May 15, 2006

SUBJECT: SPLIT SAMPLING OF CONTAMINATED GROUNDWATER

Braidwood Split Sample #1

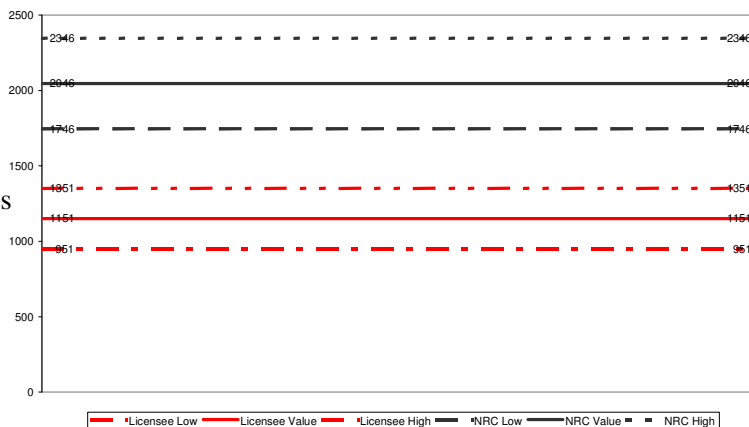
Reasonably consistent? Hardly.

The first split sample is so inconsistent that the uncertainty bands don’t even overlap as clearly illustrated in the graphic. **The NRC’s point value is 77 percent higher than the licensee’s point value.** If the NRC’s split sample here is “reasonably consistent” with the licensee’s results from the same sample of water, than it would be equally reasonable to assume that every result reported by exelon could really be doubled.
